February 12, 2019

Questions & Answers – Office Furnishings for McNair Hall Phase 1.3 and 1.4 Renovation

LG01
 Created : 12/18/2018
 2019/02/11 REVISION 3

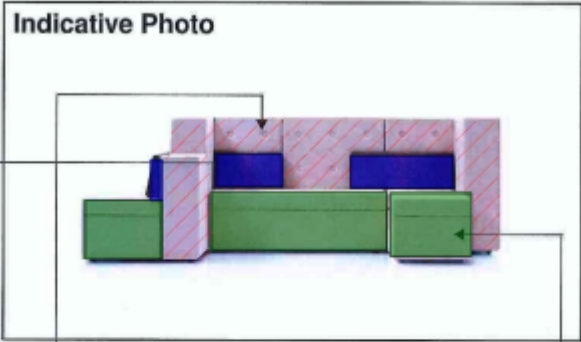
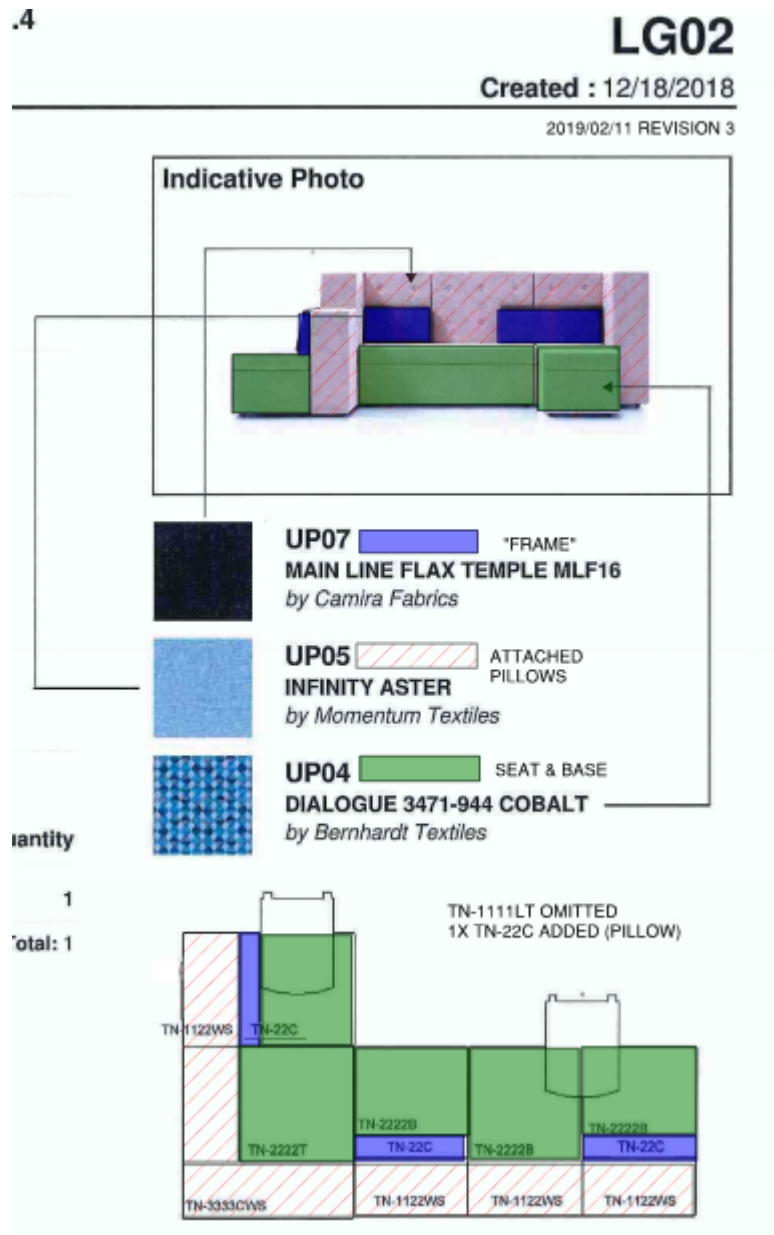
1. Please clarify where the finishes need to go on LG01 & LG02. (See attachment) The arrows indicating the fabric locations don't match the finishes to the left in the description.

TN-1111LT OMITTED
1X TN-22C ADDED (PILLOWS)

[R. Refer to attached snapshots for upholstery location.](#)
